Groundwater Application Review Summary Form

Application # G- 18648

GW Reviewer Joe Kemper Date Review Completed: 1/10/2024

PUBLIC INTEREST REVIEW FOR GROUNDWATER APPLICATIONS

Figure 3. Water-Level Trends in Nearby Wells

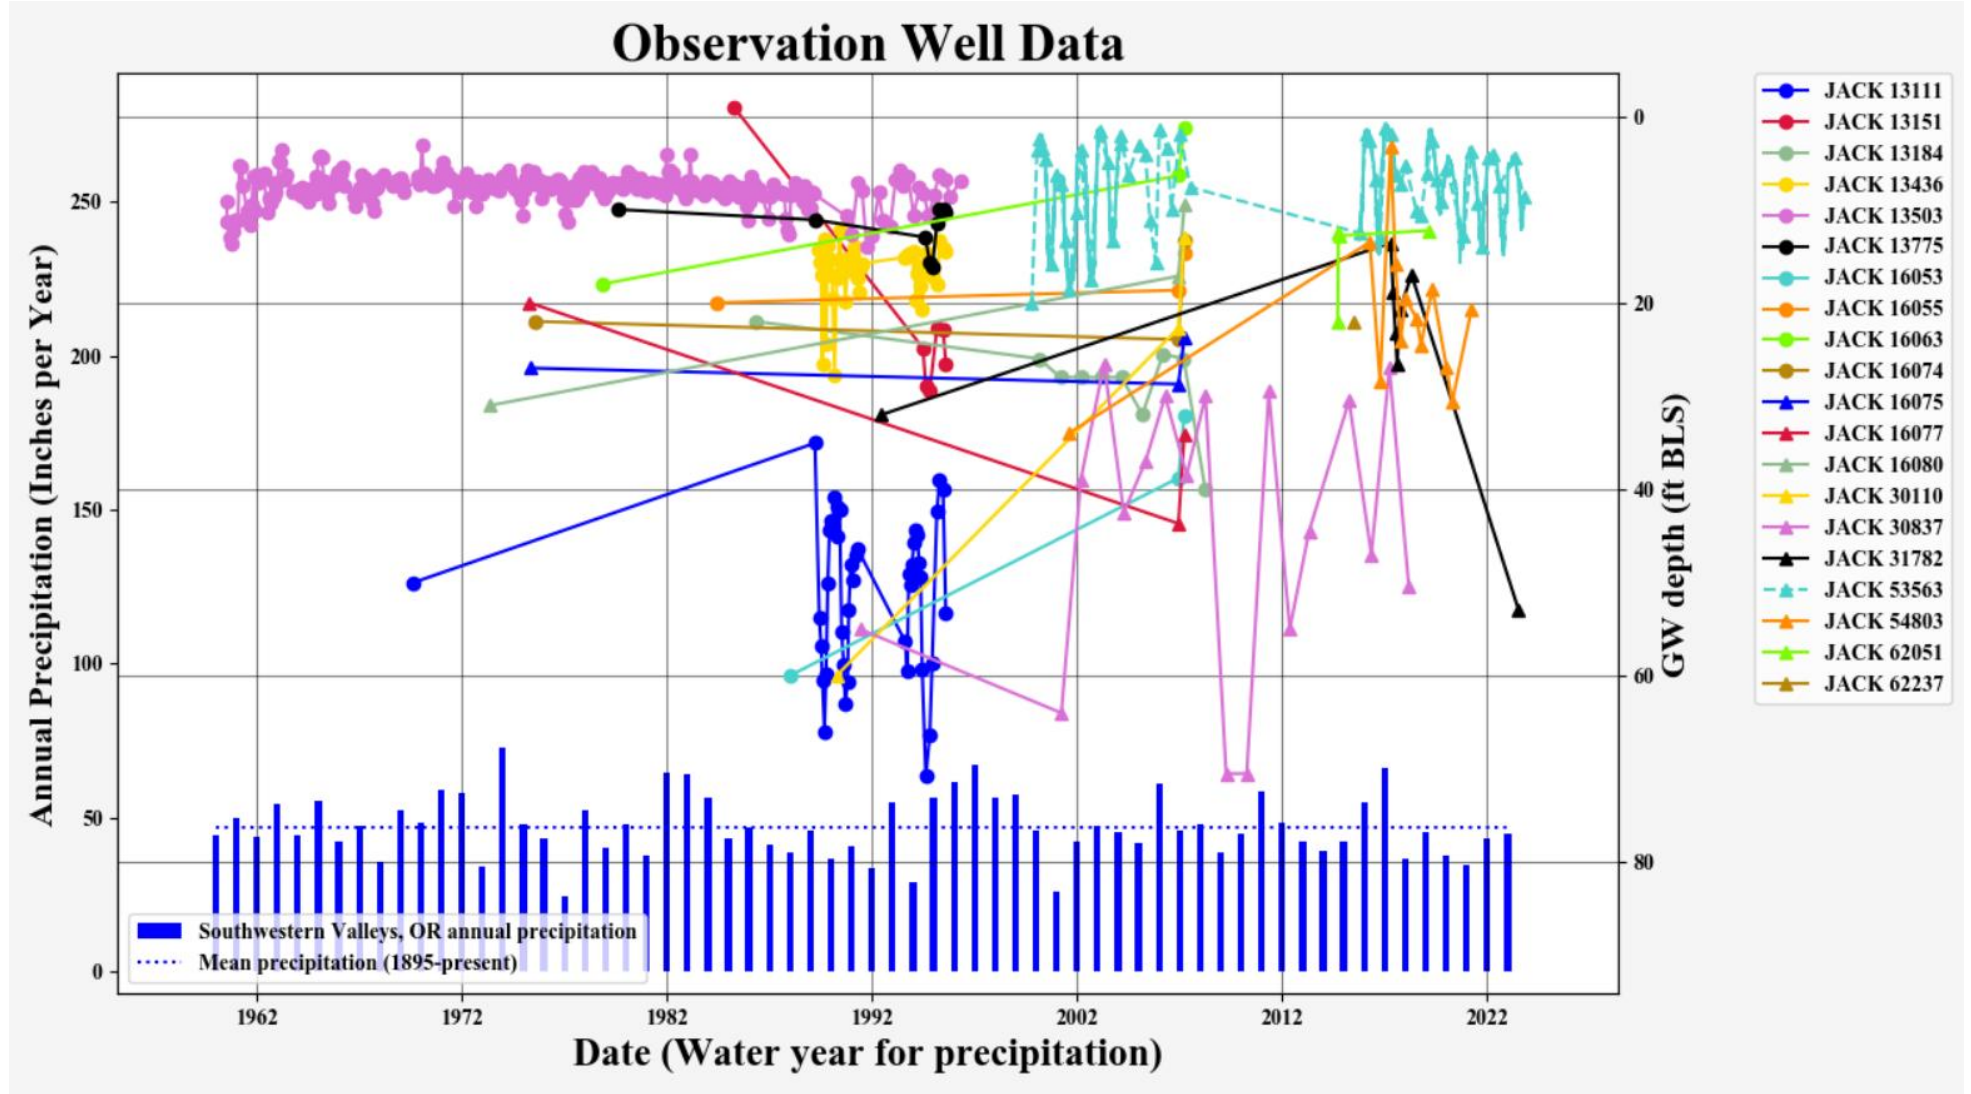
B3. **Groundwater availability remarks:** The applicant’s well would produce from a fractured bedrock aquifer system in metasedimentary units of the Applegate Group. There are moderate water level data records in the area to establish recent or historical trends with high confidence. The target aquifer does not appear to be experiencing persistent, year-on-year declines. Similarly, the well is located in the lowlands of the Bear Creek valley where groundwater flowpaths are converging, so it is unlikely that the target aquifer has declined excessively. There are no reasonably accurate water budget estimates available for the target aquifer. Considering the available information and generally accepted hydrogeologic principles, there is not a preponderance of evidence that the target aquifer is over-appropriated.

Figure 4. Stream Depletion Model

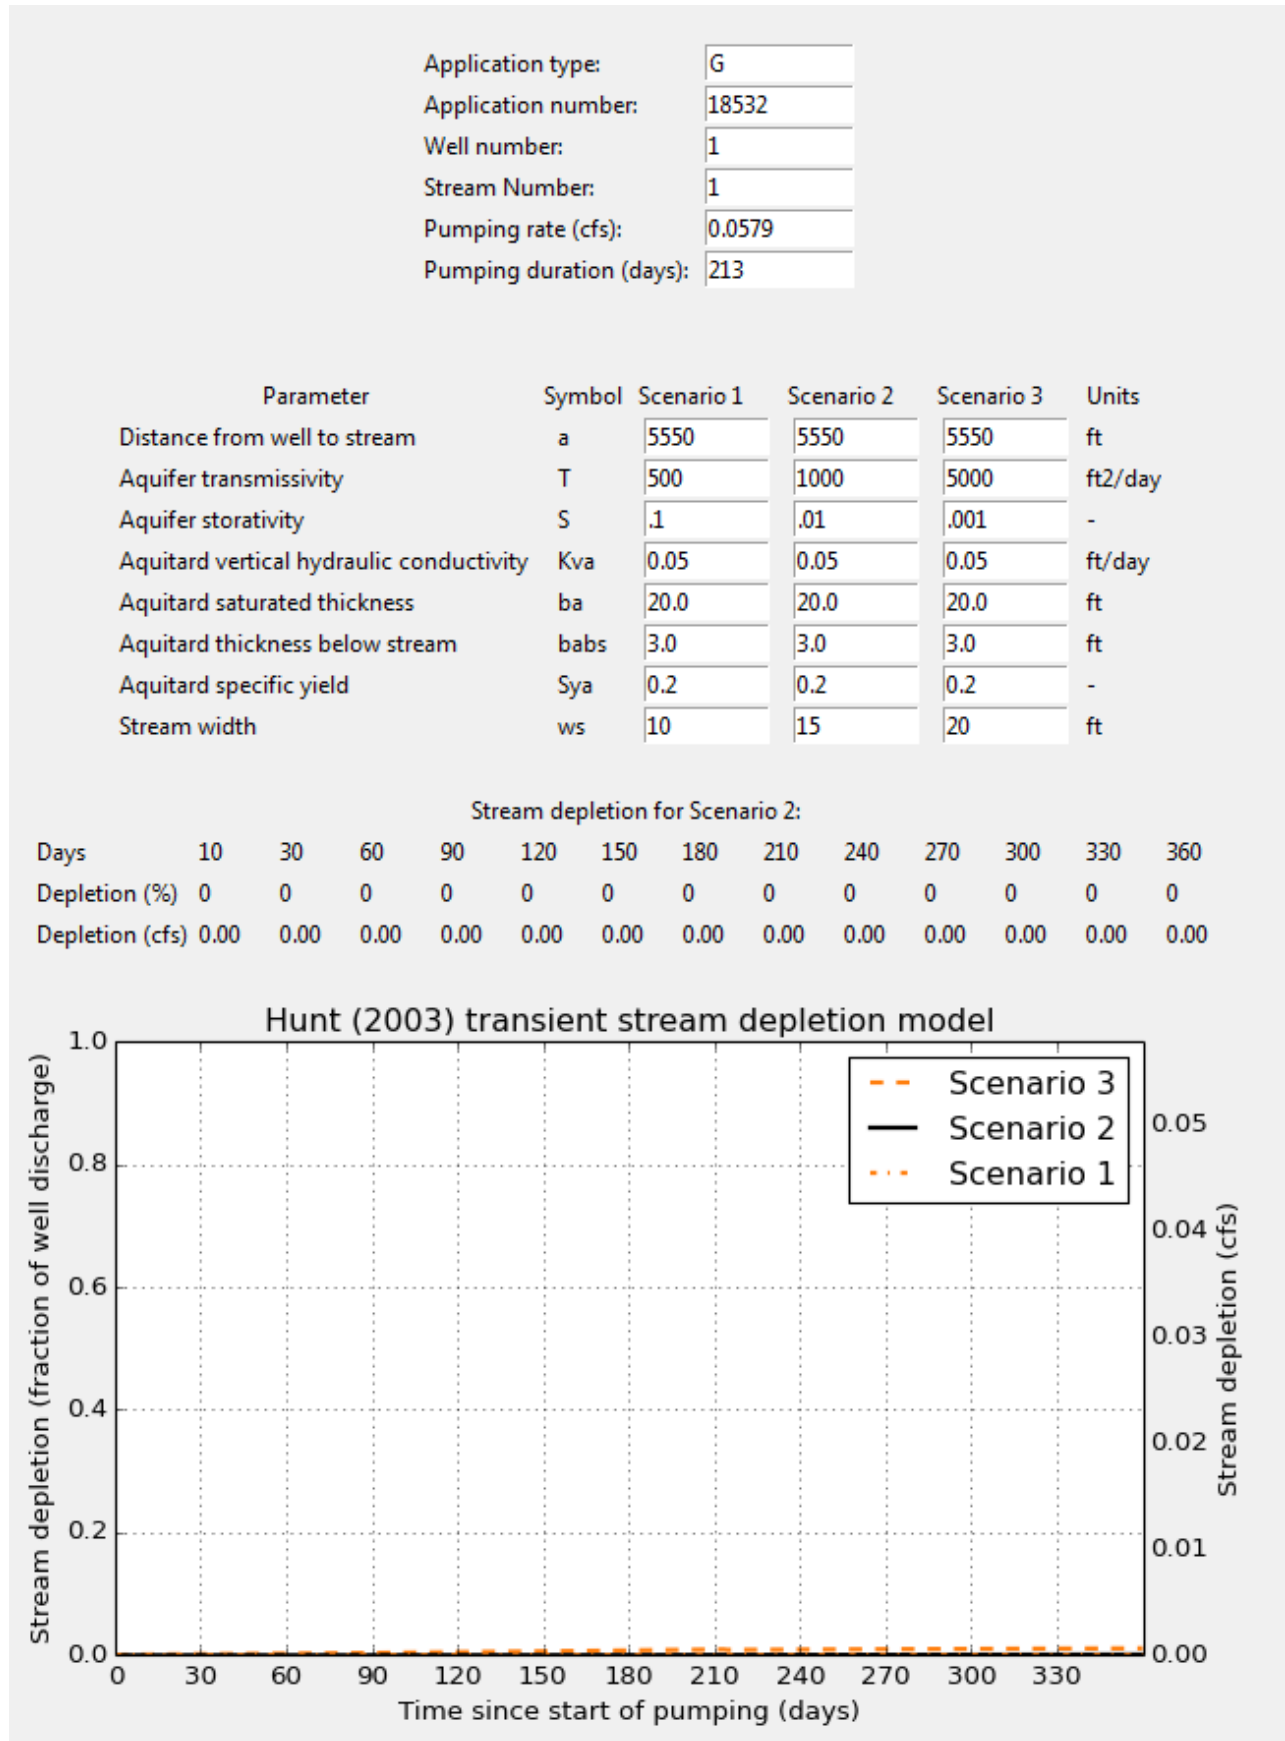
Basis for impact evaluation: Pumping effects on adjacent surface water sources are evaluated using the Hunt (2003) stream depletion model with aquifer parameters representative of the local geology. Parameters and results for the closest well-surface water source combination are presented in Figure 4.
